# Work Order ID 93860

Item Name: Crosstube Fwd High

DRAWING NO. D212-664-141	TITLE XTUBE ASSY (205/212/412 HI FWD)	REV. D	DART AEROSPACE LTD ENGINEERING ORDER		D.E.O. NO. D212-664-141-D-1	SHEET NO. SHEET 1 OF 2	SCALE NTS
DRAWN	CHECKED	MFG. APPR.	APPROVED	DE APPR.			
DATE 11.04.07	DATE 11.07.11	DATE 11.04.12	DATE 11/04/12	DATE 11.04.12

**D212-664-141/-141B  
ASSEMBLY DETAIL**

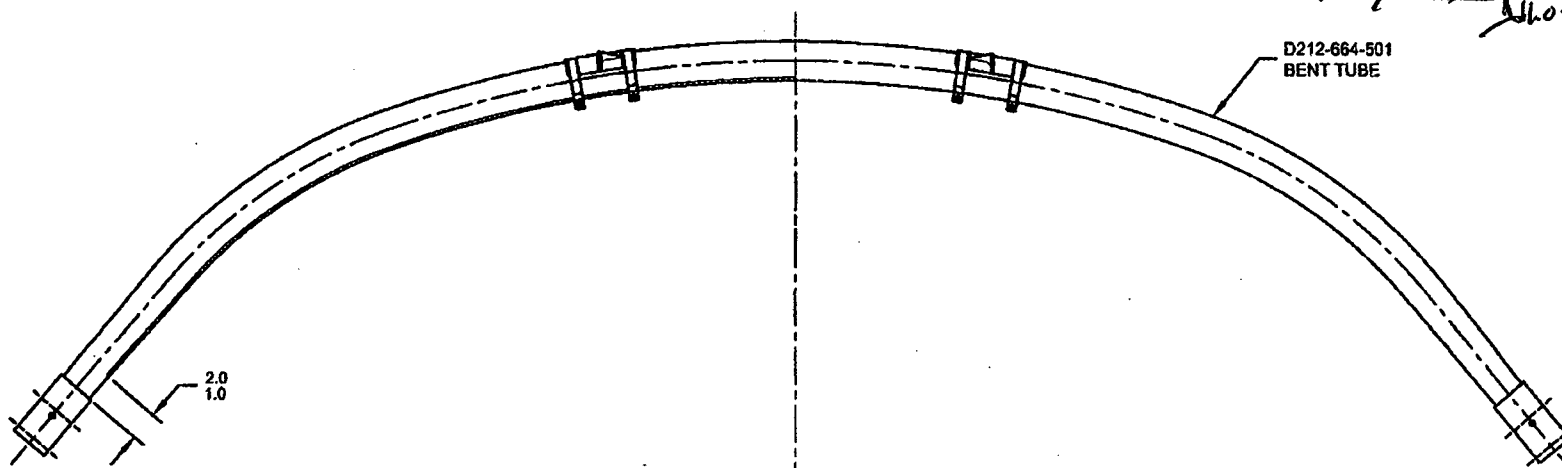
ADD AN INSPECTION WINDOW TO UNDERSIDE OF CROSSTUBE.

NOTES 2 OF SHEET 1 IS AMENDED AS FOLLOWS:

- 2) FINISH: CHEMICAL CONVERSION COAT PER DART QSI 005 4.1  
PRIME INSIDE AND OUTSIDE PER DART QSI 005 4.2  
MASK UNDERSIDE OF CROSSTUBE AS SHOWN (HATCHED AREA) AND  
PAINT OUTSIDE PER DART QSI 005 4.2  
REMOVE MASKING AND APPLY CLEAR COAT

MASK AREA PRIOR TO PAINTING,  
REMOVE MASKING AFTER PAINT  
AND APPLY CLEAR COAT
